MEETING #2 NOTES

Eastern Corridor Segments II and III

US 50 Corridor Focus Area

Figure I-13D
BETTER SIGHT DISTANCE AND CURB BUMP OUT
TO SHORTEN CROSS WALKS

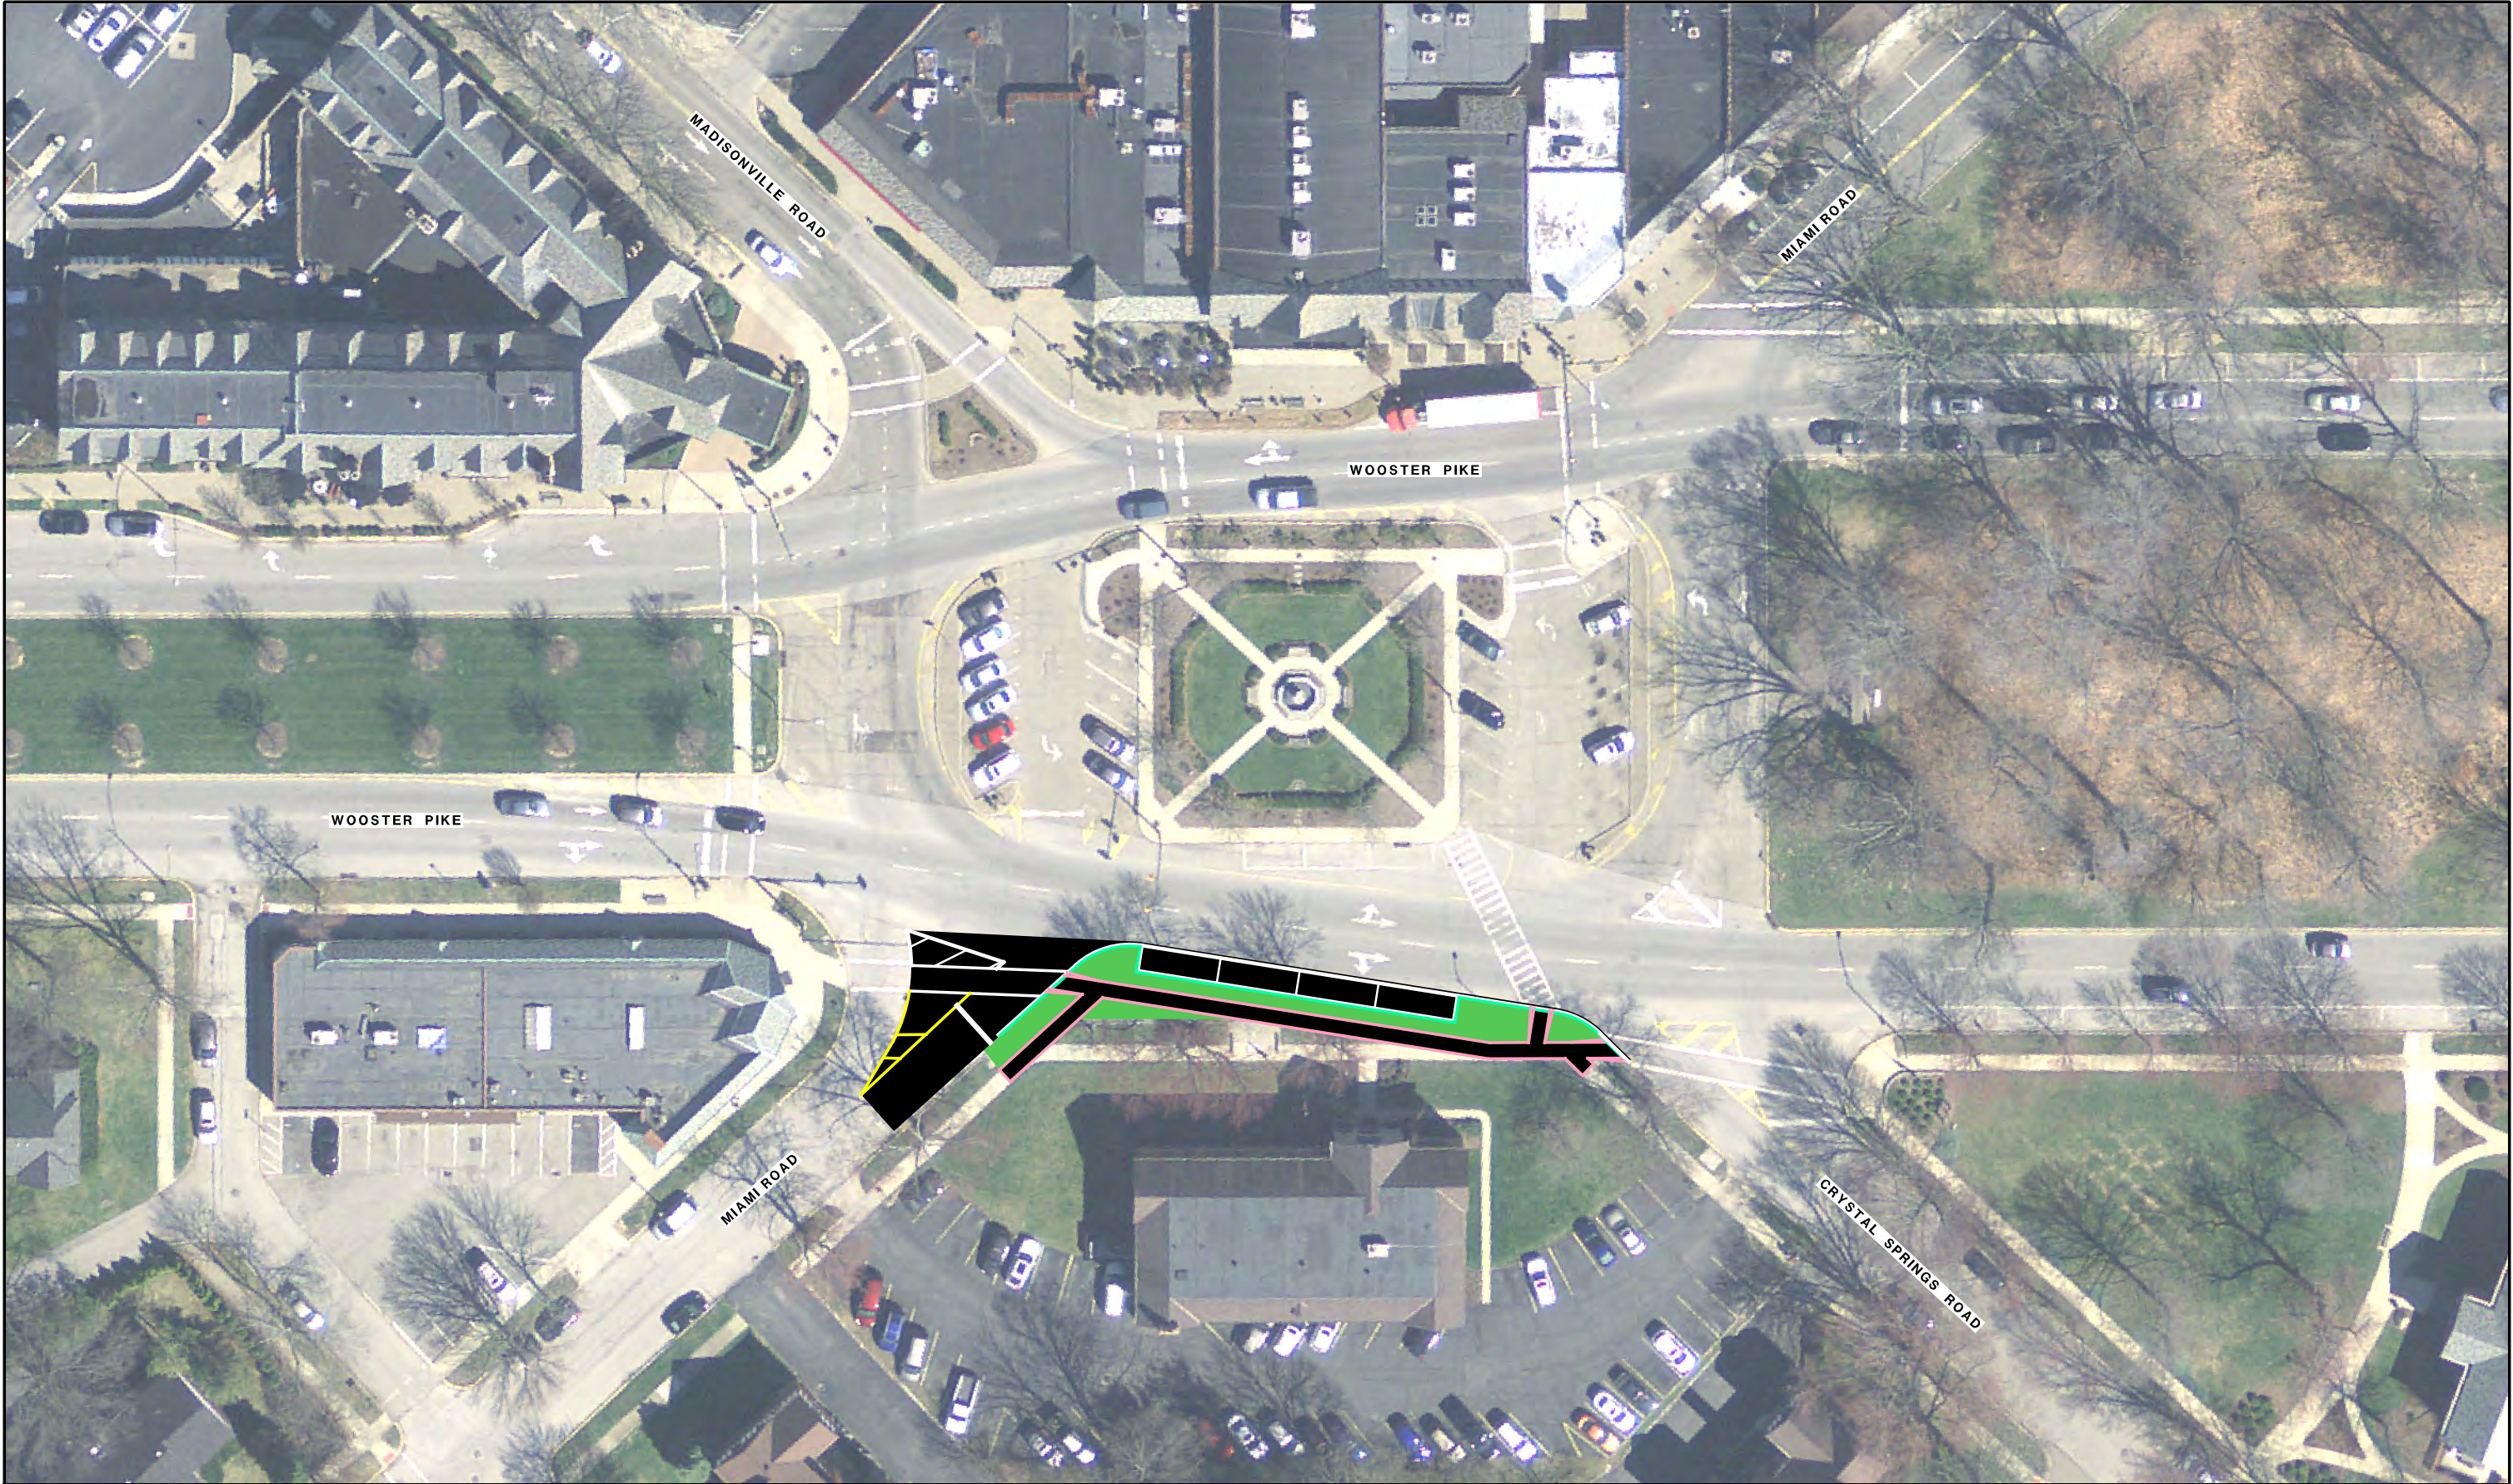
- This concept is intended to address a sight deficiency for drivers traveling northbound on Miami Road and turning right onto Wooster/US 50 (south side of Mariemont Square). This movement is currently not signalized.
- A curb bump would be added, moving the stop bar (line in the road) forward so that drivers are better able to see past the existing building on their right.
- The concept has the additional potential benefit of straightening the existing crosswalk. This would be particularly helpful for pedestrians.
- The four existing parking spaces would be preserved.
- Pavement removed in this concept could be replaced with grass. Existing trees would be saved.
- A new raised island could be established on Miami Road, similar to the island on Plainfield Road on the north side of the Square

- Mariemont will provide sketch outlining design options. Limited time being allowed to submit comments did not allow Mariemont to submit sketch at this time. Continued dialogue is needed to address safety, parking, and aesthetics.

- Advance for further study.
- Work with Mariemont on concept development.

Figure 50-5
RESTRIPE PAVEMENT TO MAINTAIN TWO LANES
IN EACH DIRECTION ON WOOSTER PIKE

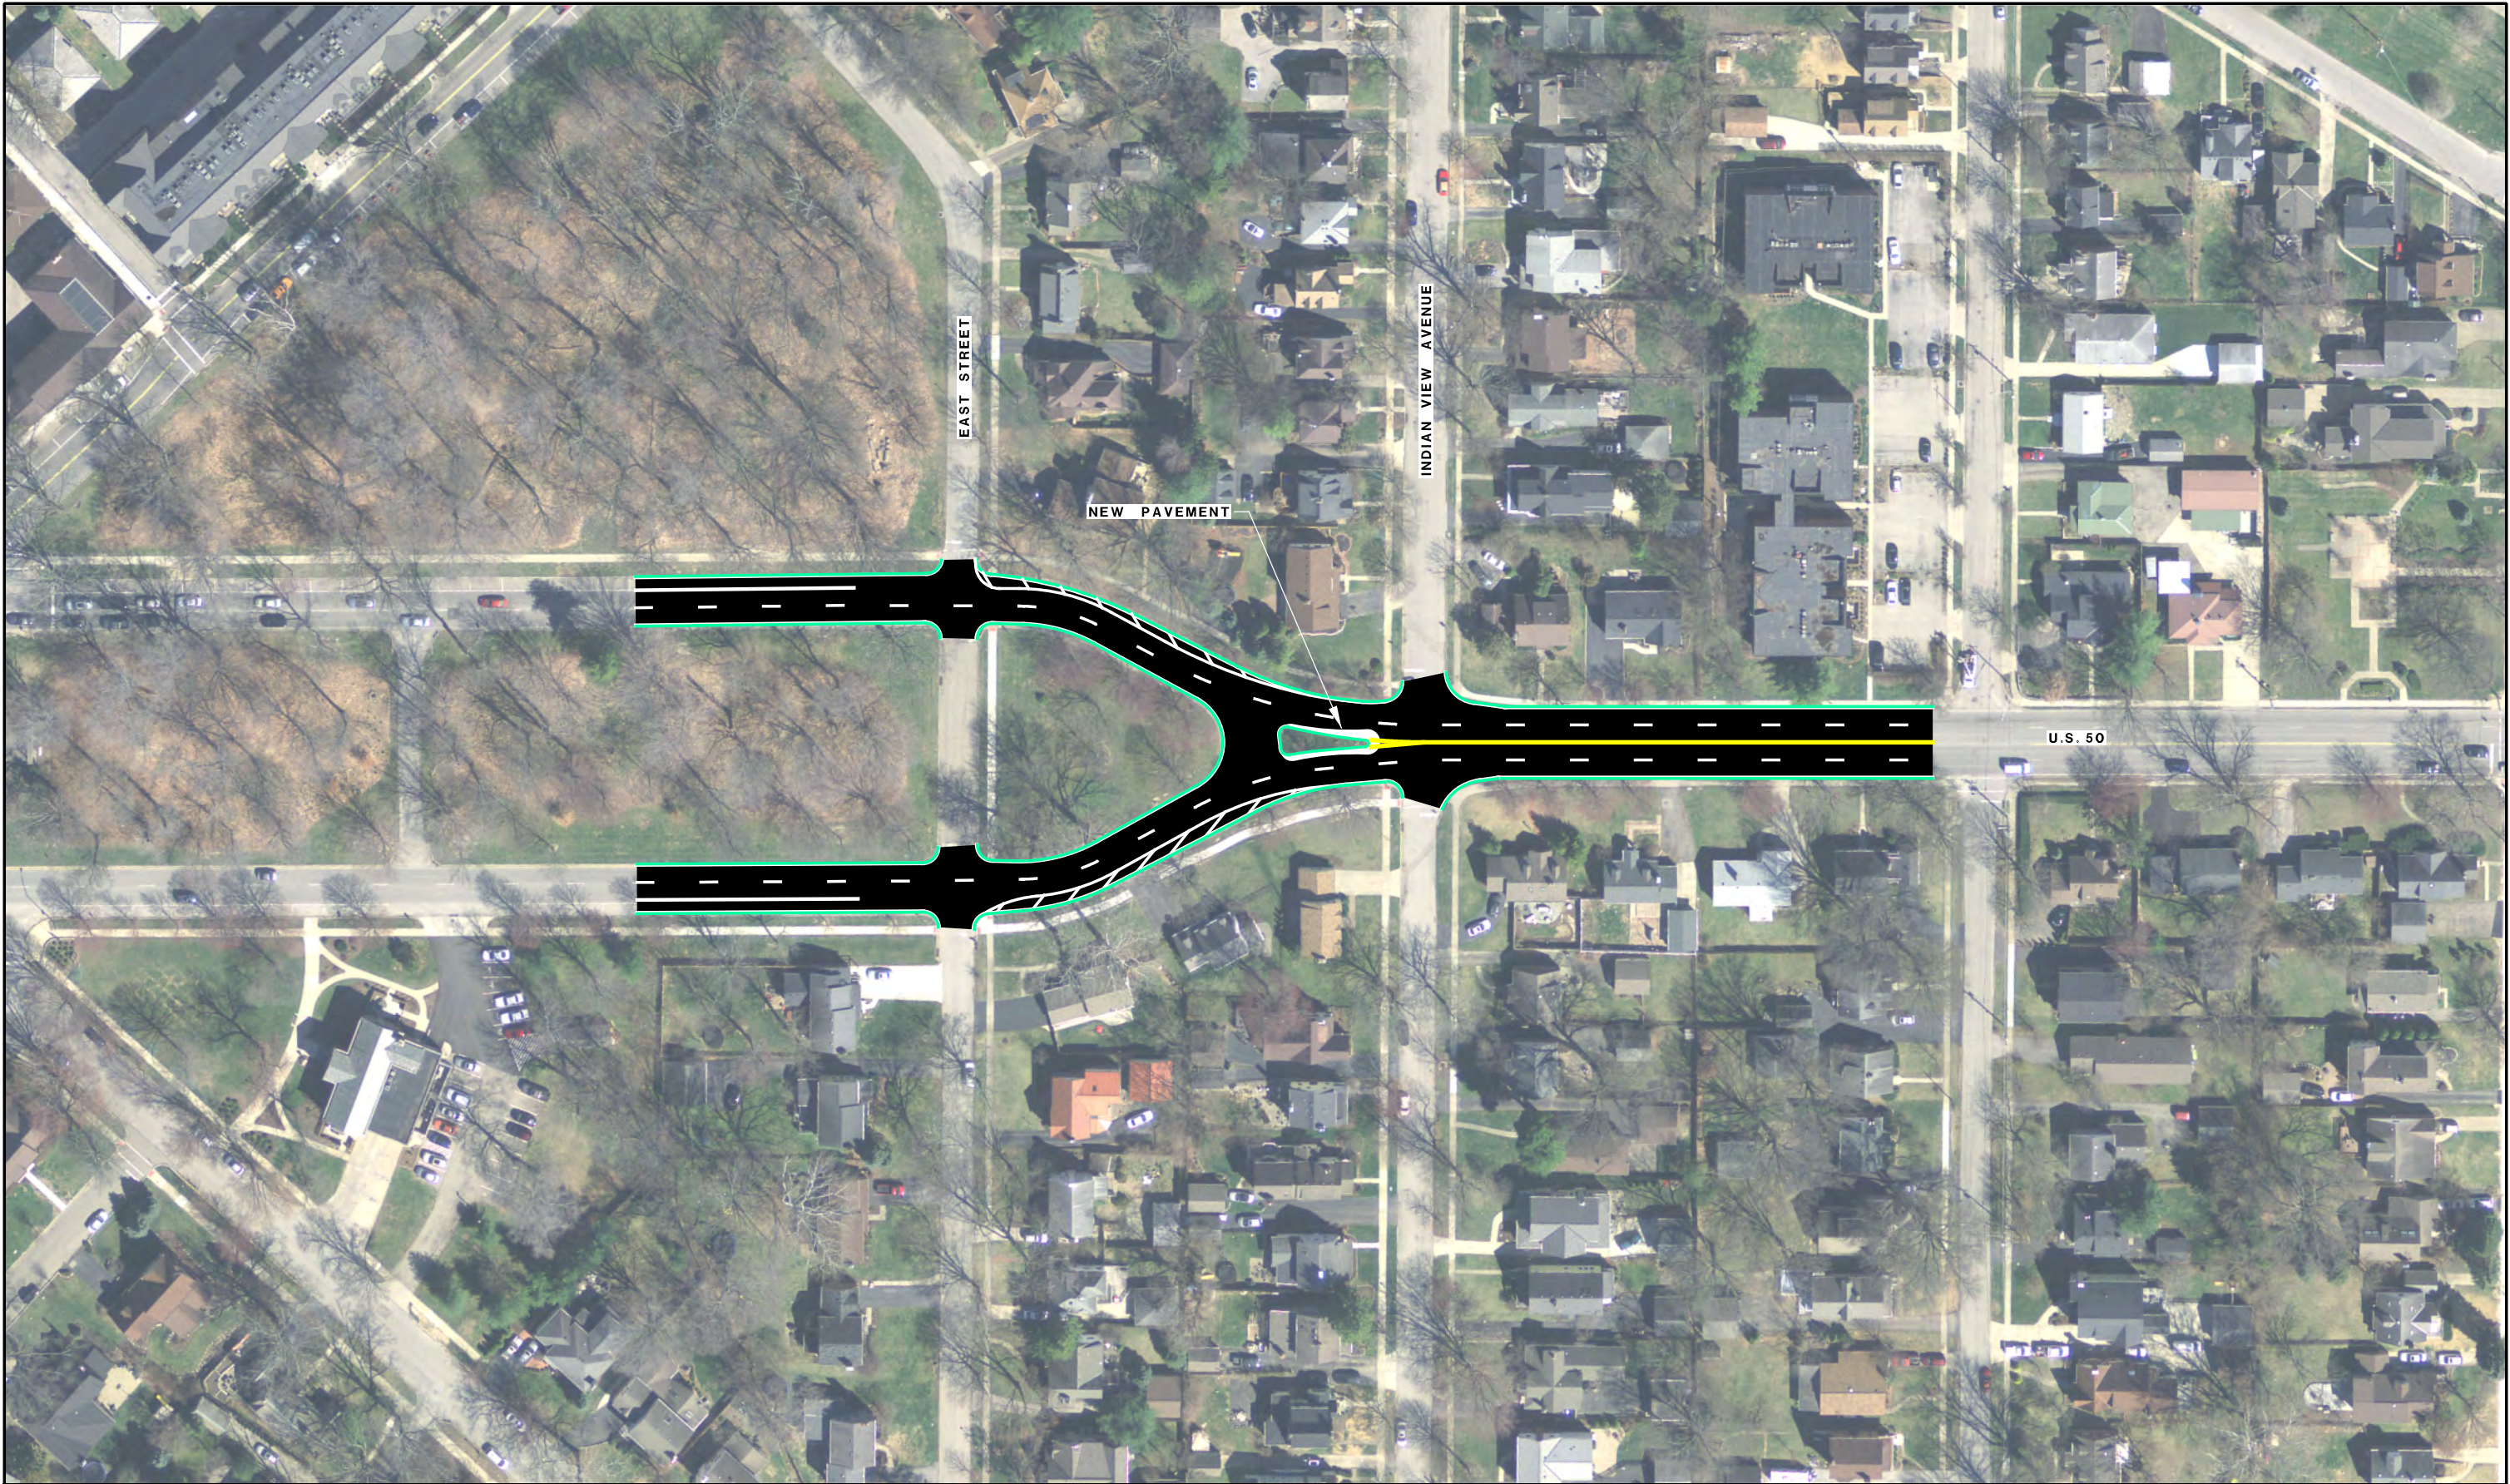
- People aware of the existing travel pattern in this area begin merging as far back as the Pocahontas Avenue signal, resulting in delays at Pocahontas and US 50 and inefficient lane utilization from this intersection through the Square.

- A minimal amount of space from each island (one foot, either side) new pavement would be needed to implement this change; work can be done in conjunction with PID 101309 to be completed in 2019.

- New pavement would be added by narrowing the island by 1 foot on each side) and restriping the existing lanes
- The concept would require reducing speed in this area from 35 to 25 miles per hour.

- The Village could do this by defining the area as part of the Central Business District.
 - Another option is to conduct a speed study to determine if a lower speed is warranted.

- The committee suggested the following:
 - Providing two westbound travel lanes may encourage drivers to speed up through Mariemont.
 - Providing two travel lanes may result in the rear-ending of stopped drivers turning left on Indian View Avenue.

- John Nolen purposely designed the turns in the road at this location to slow traffic down; this idea should be preserved.

- Mariemont does NOT support widening to two lanes in either direction. Current traffic pattern aids in eastbound and westbound traffic safely accessing side streets on south side of Wooster Pike (US RT 50) and aids in calming traffic as it flows into Mariemont Square where there is a larger concentration of pedestrians and businesses. Traffic entering Mariemont from the West is not travelling at a high rate of speed. Concept Development Summary matrix provided by ODOT does not accurately depict safety concerns, traffic operations, right-of-way impacts, environmental impacts, and community impacts. The current traffic flow is an important part of John Nolen's design for the Village of Mariemont, a National Historic Landmark community, and should be retained.

- Advance for further study.
